Bulletin

MODEL: BENTLEY MARK VI

MODIFICATION.FOR CATEGORY 2 ACTION:REAR BUMPER SUPPORT BRACKETS.

MODIFICATION.For Category 2 Action:REAR SHOCK DAMPER LINKS.

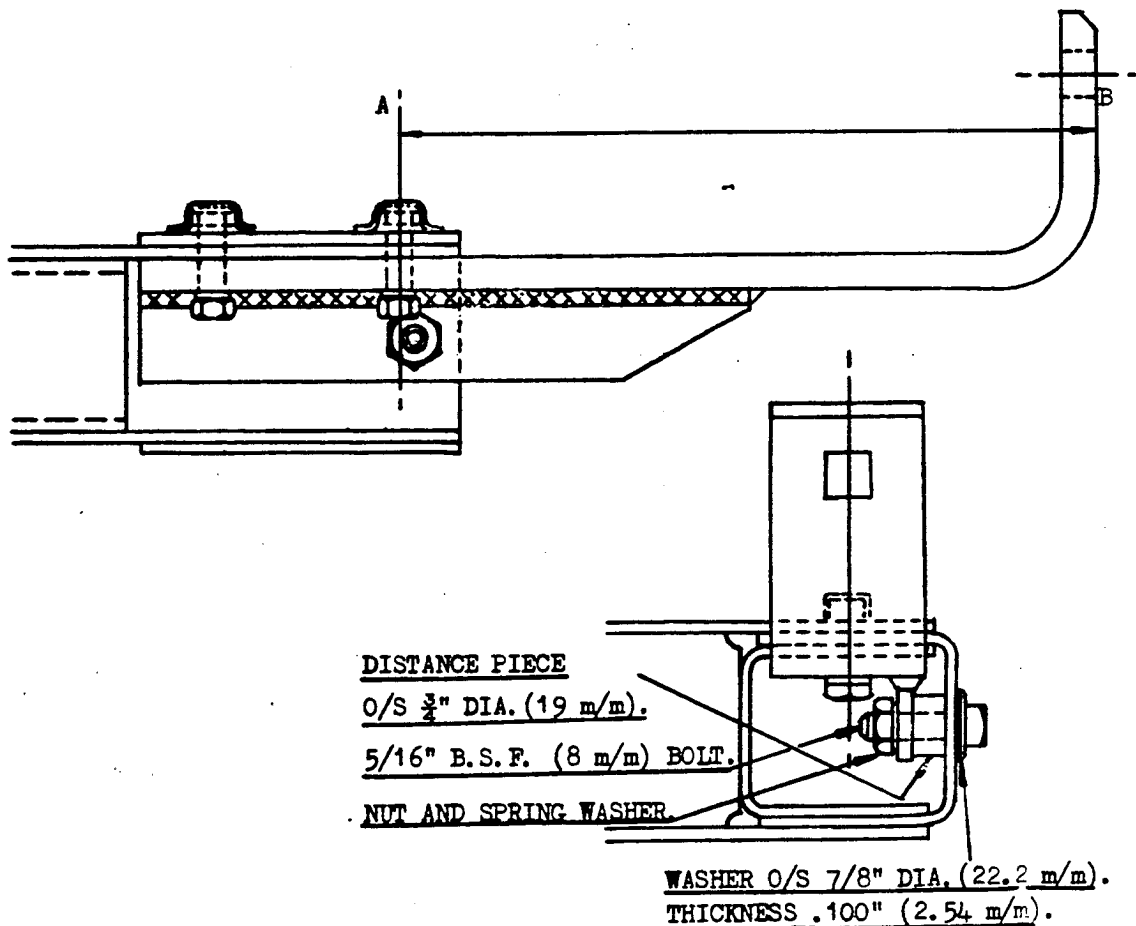
The length of the rear bumper support brackets on the Bentley Mark VI Chassis is dependent upon the type of body fitted. In cases where the body design causes the length of the bumper support from the rear fixing bolt (A) to its rear face (B) to exceed 8" (20.3 c.m.) a modification is introduced to ensure maximum rigidity.

This modification secures the bumper support stiffening webs to the side walls of the chassis members in the manner shown in the attached drawing.

A 5/16" (8 m.m.) clearance hole is drilled through each stiffening web of the bumper support brackets and chassis frame side member at a point $\frac{1}{2}$ " (12.7 m.m.) from the end of the chassis frame, and $1\frac{1}{16}$ " (27 m.m.) from its top face. The two parts are bolted together with a distance piece interposed and a plain washer on the outside of the frame.

The distance piece must be a tight push fit between the stiffening web and the chassis frame side wall before the assembly is bolted in order to prevent any stress or distortion when the bolt is tightened. The distance piece supplied has a thickness of .450" (11.4 m.m.) which must be reduced to suit the individual requirements of the chassis.

PRE-MODIFIED ASSEMBLY

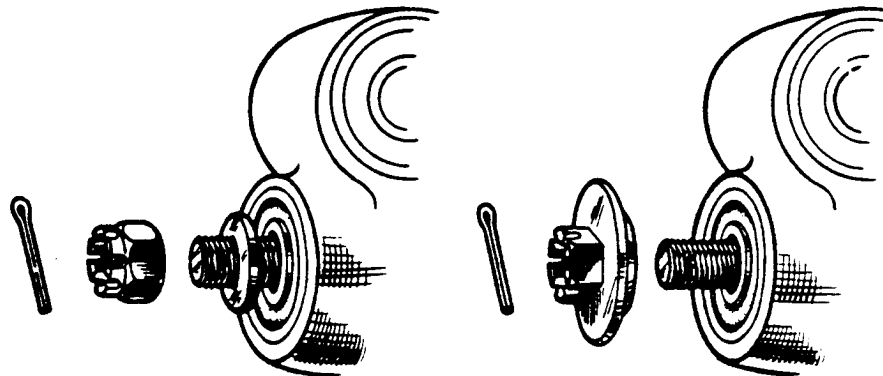
A modified type of retaining nut is now specified for the Silentbloc bush which connects the rear spring pad stud to the shock absorber linkage. The new nut has a flange, the diameter of which is greater than the bore of the knuckle into which the bush is fitted.

It is intended that this flange should act as a safety device to prevent the shock absorber linkage becoming detached from the spring pad stud, if severe road conditions cause the Silentbloc bush rubber to shift in its housing.

Before fitting the new nut, the Silentbloc bush should be examined; if there are no signs that the rubber has moved in relation to the bush, there is no necessity to change the bush, but if it appears that the rubber has started to creep out of the end nearest the front of the car, it should be renewed.

Arrangements have been made for all Retailers to receive a quantity of the modified nuts, part No: RF-6448, and shock absorber knuckles complete with bushes, part No: FB-3049A. Further supplies may be obtained when necessary from the London Service Depot. Retailers are requested to return the original knuckle unless the cost of forwarding makes return impracticable.

This modification has been incorporated on production from chassis No B-268-DA onwards and all earlier cars should be dealt with on a Category 2 basis.

Fig. 1. Parts to convert Standard cars

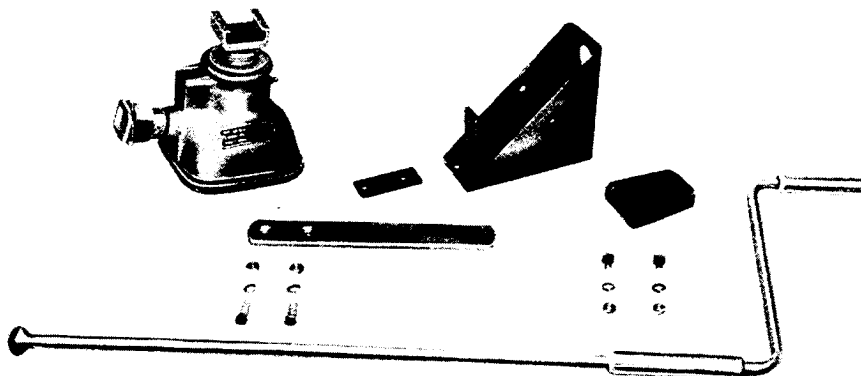
In order that the Dunlop jack may be used, the two existing 3rd body mounting brackets must be removed from the chassis and replaced by the later type of mounting bracket (RF.6007). This bracket is provided with a slide bar adaptor which is welded in position on the bracket.

Shown in Figure 1 are the material requirements necessary to convert one of the two 3rd. body mounting brackets; also shown are the Dunlop jack and handle.

Fig. 2. Dimensions for fitting Support Brackets and Slide Bars

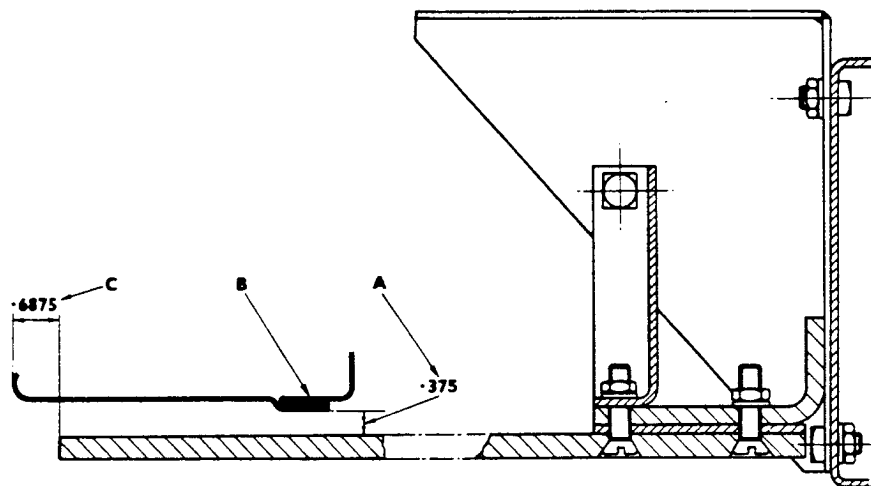
The support brackets (RF.6011) and the slide bars (RF.6015) may then be fitted to the body mounting brackets, as shown in Figure 2. Packing plates (RF.6013) should be placed between the slide bars and the body mounting brackets to give a clearance of 0.375 in. between the slide bar and the underside of the sill as shown by measurement A in Figure 2. The 0.750 in. deep flange on the underside of the sill (see B. Fig.2) should be flattened for a minimum distance of 2.000 in. on either side of the centre line of the slide bar.

Fig. 3. Stowage of Jack

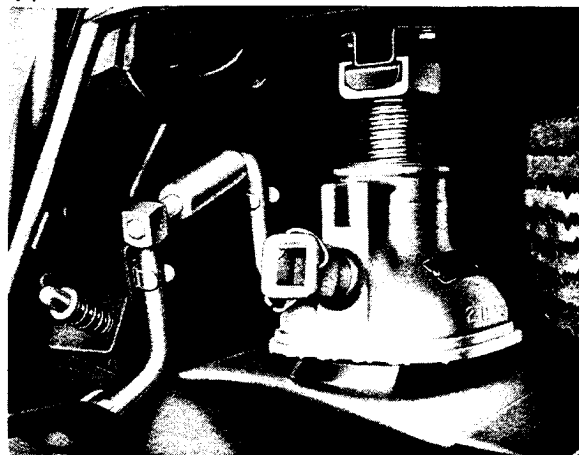
Figure 3 shows the Dunlop jack stowed in the spare wheel compartment on the left-hand side of the spare wheel. The wedge shaped wood block (RW.2340), on which the jack stands, is fitted so that its thinner end butts against the transverse rib of the floor (see A. Fig.5) and its left-hand edge is 3.125 in. from the wall of the spare wheel compartment (see B. Fig.5). The wedge is secured to the floor by two countersunk screws; these are of different lengths to allow for the variation in the thickness of the wood block.

Fig. 4. Dimensions for fitting Upper Support

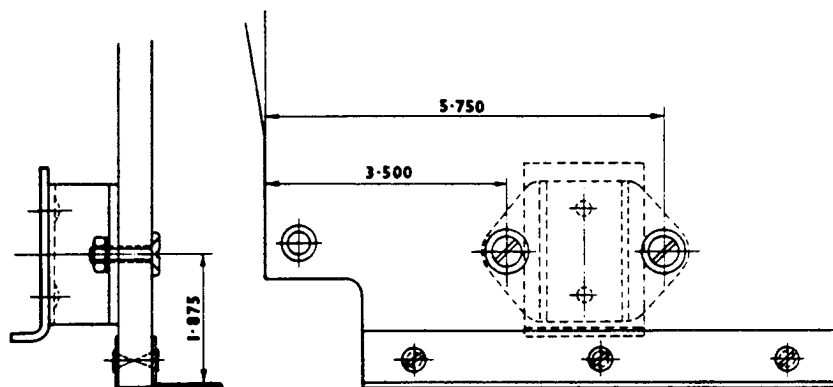
The upper support (327/257) for the jack should be fitted to the underside of the luggage floor, working to the dimensions shown in Figure 4 so that the upper support lip is facing towards the rear of the car (see Fig.5).

The upper support is secured by two $\frac{1}{4}$ in. countersunk screws and nuts.

Fig. 6. Fitting of Jack Handle Clips

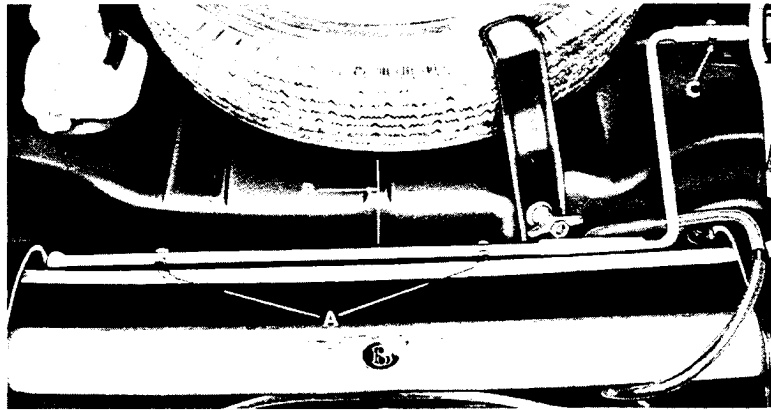
Remove the Bevelift jack clips from the well of the spare wheel compartment in order that the two rear jack handle support assemblies (327/256) may be fitted.

Detach the lower boot door sealing rubber at the two points marked 'A' in Figure 6, sufficiently to enable two 4BA clearance holes to be drilled through the sealing rubber securing flange. Taking the centre of the stiffening rib of the spare wheel compartment floor as a datum line (see B. Fig.6) drill the two clearance holes at points 10 in. to the left and 4.500 in. to the right of the datum line. Secure the two jack handle rear supports in position with two 4BA screws and nuts, using the two upper holes in the supports. The countersunk heads of the screws should be on the outer side of the sealing rubber securing flange. Refit the rubber seal. Using the two lower holes in the support brackets as guides, drill two 3BA clearance holes through the floor of the well at the rear of the spare wheel compartment, then secure the rear supports with two 3BA screws and nuts.

Fit the jack handle in position in the two rear supports and clip the front support (327/258) to the centre of the jack handle grip (see C. Fig.6). Lay the handle grip on the floor of the spare wheel compartment, then using

Fig. 7. Parts to convert Coach-built Cars

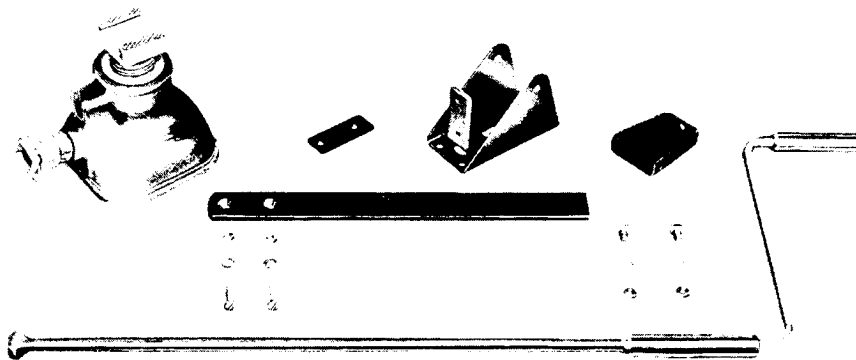
The procedure adopted for converting the jacking system on coachbuilt cars is basically the same as for the standard body. The conversion should be carried out in the same manner except where stated otherwise in the following paragraphs. Figure 7 shows the material requirements necessary to convert one of the jacking brackets; also shown are the Dunlop jack and handle.

Fig. 8. Dimensions for fitting Support Brackets and Slide Bars

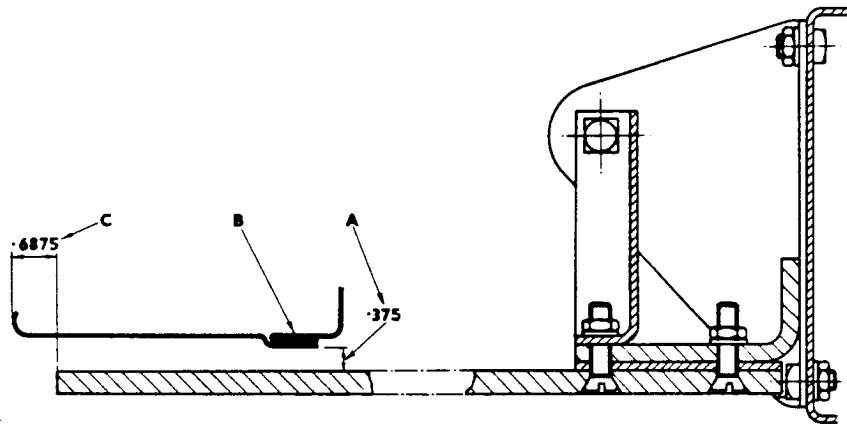
The jacking brackets used on coachbuilt cars do not act as body mounting brackets, therefore the operation of removing the existing Bevelift jacking brackets and fitting the later type brackets (RF.6009) is greatly simplified. Fit the brackets as described previously. When fitting the slide bar, it may be necessary to trim the end of it in order to obtain the correct clearance between the edge of the sill and the end of the slide bar. (see C. Fig.8).
